WATER PERMIT NO. 2126-2

WATER PERMIT APPLICATION NO. 2126-2 WARD DAM PROJECT

REVISED REPORT
ON APPLICATION NO. 2126-2
U. S. FOREST SERVICE
July 16, 1990

SD-091-01
WARD DAM
SITE PLAN, MARSH DATA, PROFILES

FIGURE 2

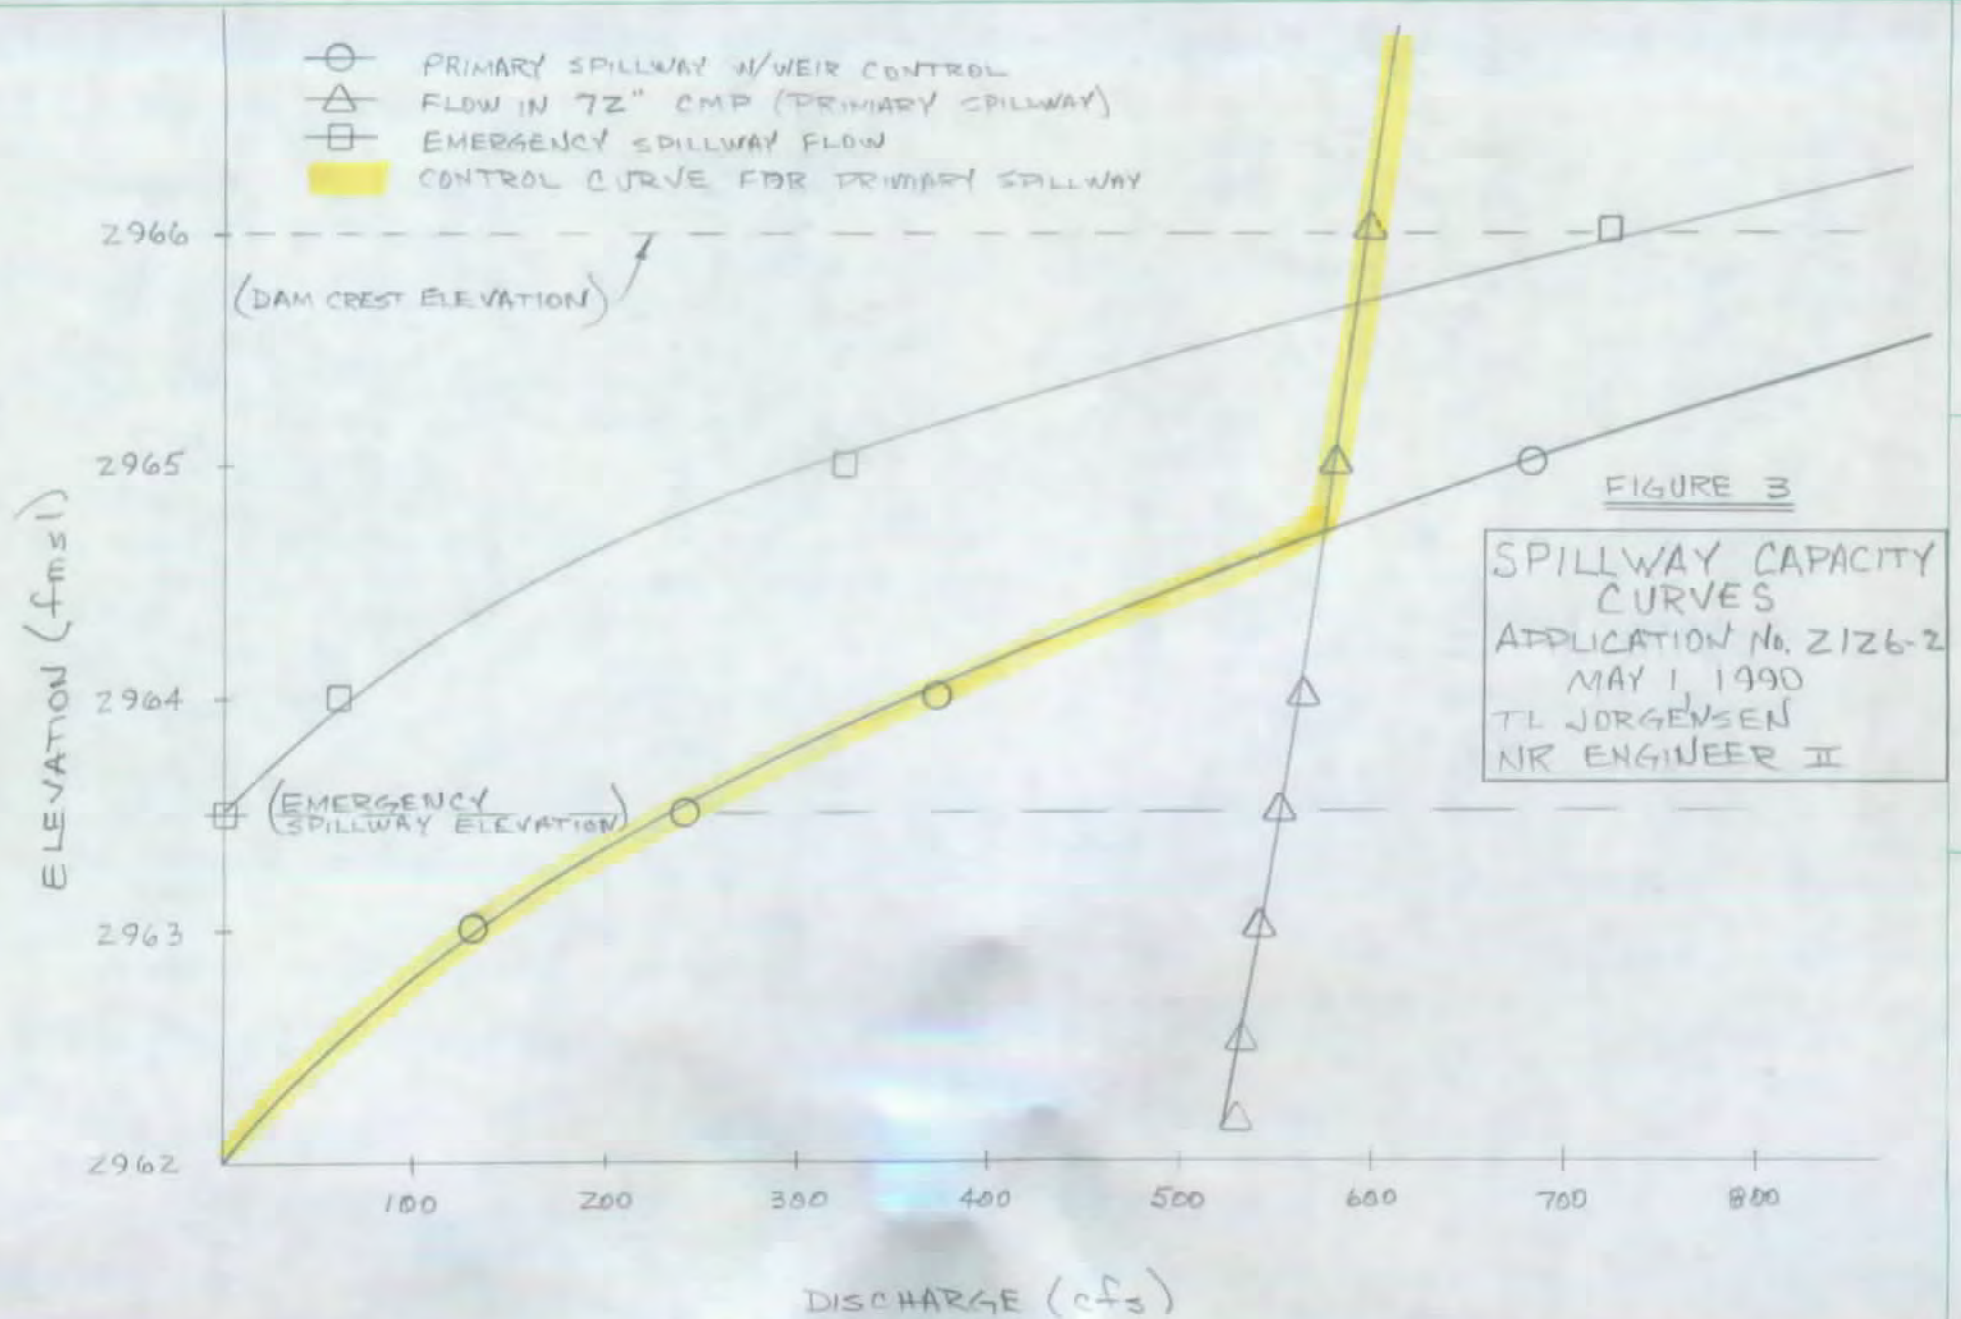
Ward Dam will impound water from an unnamed tributary of Antelope Creek and will be located in the SW1/4 NW1/4, Section 33, T1S, R10E, Pennington County, SD. The drainage basin for the proposed structure covers 1078 acres (1.7 square miles) and will produce a peak discharge of 735 cfs during a 25 year storm event (see FIGURE 2).

FIGURE 1.
WARD DAM
DRAINAGE BASIN
APPLICATION No. Z126-Z
MAY 1, 1990
T L JORGENSEN
NR ENGINEER II

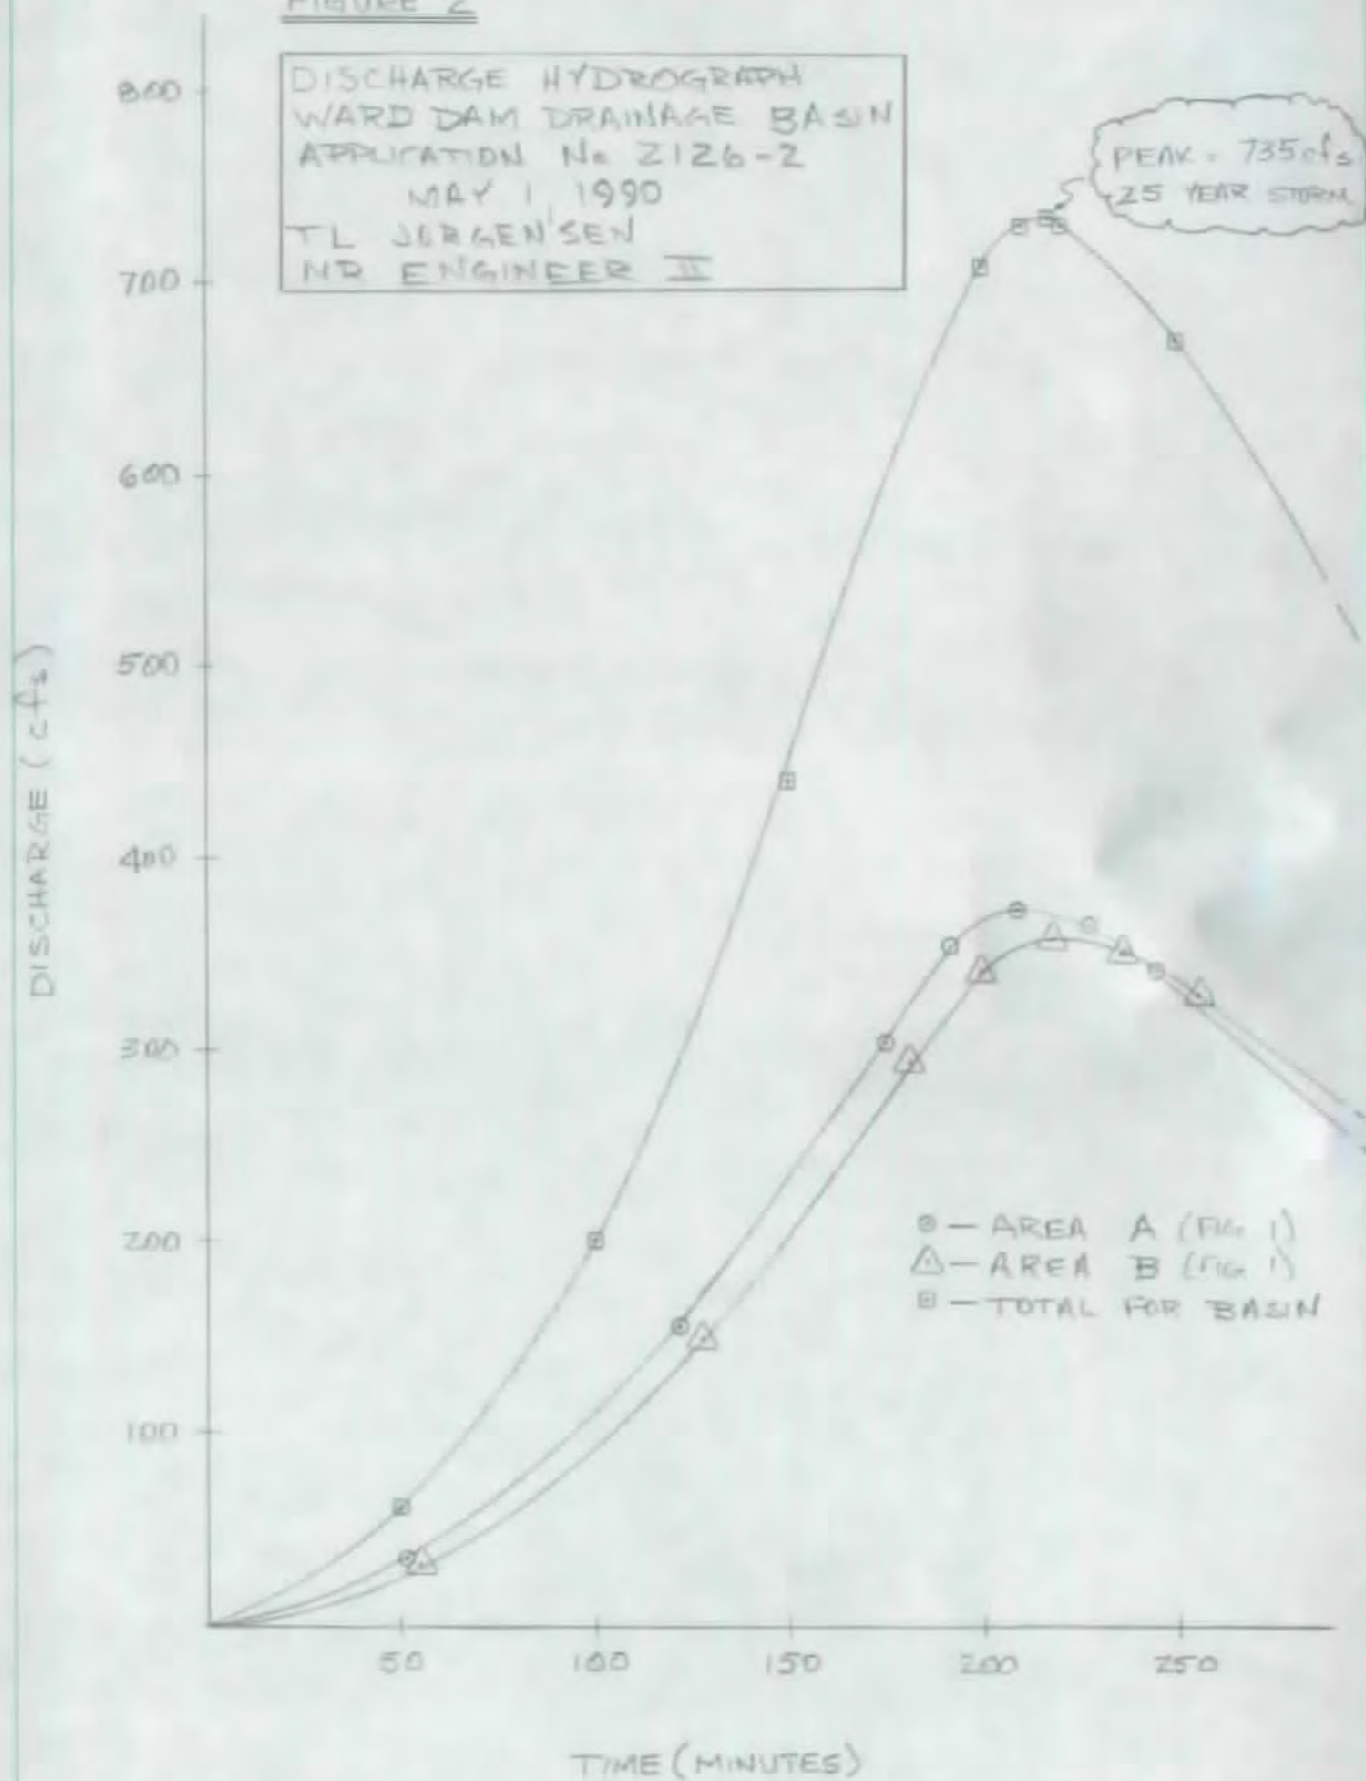
Ward Dam will impound water from an unnamed tributary of Antelope Creek and will be located in the SW1/4 NW1/4, section 33, T1S, R10E, Pennington County, SD. The drainage basin for the proposed structure covers 1078 acres (1.7 square miles) and will produce a peak discharge of 735 cfs during a 25 year storm event (see FIGURE 2).
